Product  
Safety  
Bulletin  
PSB-16.003

Date August 12, 2016

*This procedure only effects AB46JE, A46JE, AB46JRT and A46JRT machines.* The purpose for this SAFETY RELATED BULLETIN is to inspect and ensure the Slave Level Stepped Pins SOCKET HEAD CAPSCREW are torqued properly. Failure to comply with this SAFETY RELATED BULLETIN could result in DEATH or SERIOUS INJURY. This inspection should take approximately 1 hour. During the inspection process, if you determine the bolts are not properly torqued, please contact the Snorkel Service Department with the model, complete serial number and hour meter reading.

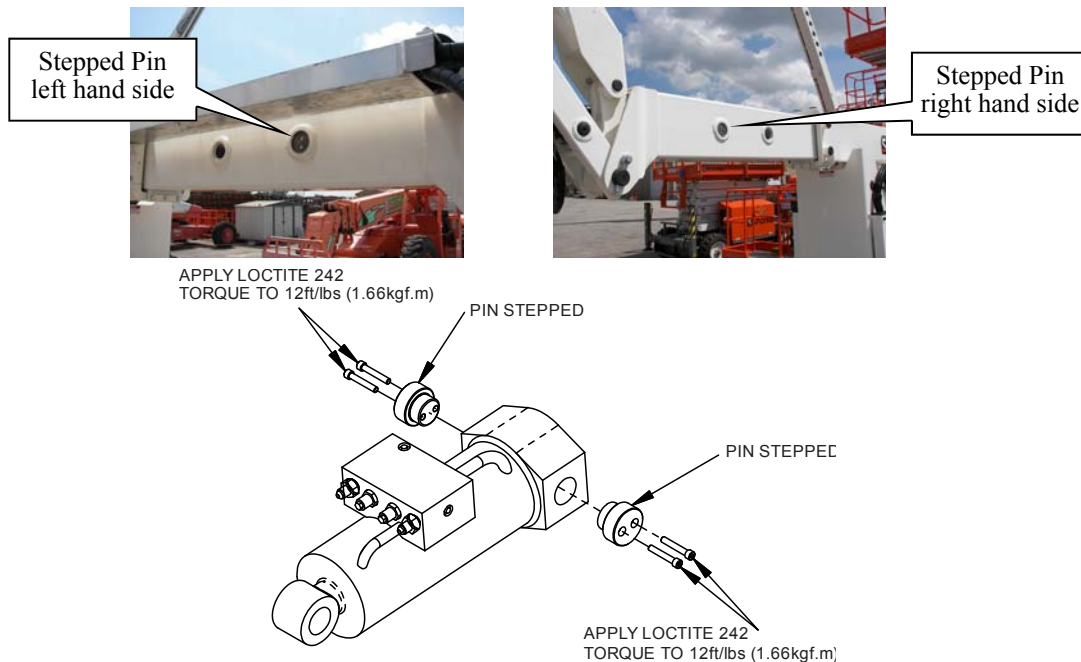
At lower controls, extend tip boom out approximately two to three feet. Using a Hex key remove the two SOCKET HD CAPSCREWS, .250-20 UNC STL 1.50 LG that secures stepped pin (s) to the slave level cylinder trunnion mount and tip boom. Inspect both socket head cap screws for abnormal wear and proper torque, record findings and report to Snorkel, as instructed above. Then replace the bolts with Snorkel P/N 978419, Qty. 4. Apply Loctite 242 P/N 8120071 to threads and reinsert socket head cap screws into stepped pin and lightly tighten. Using a torque wrench, torque each socket head cap screw to 12ft.lbs or (17Nm).
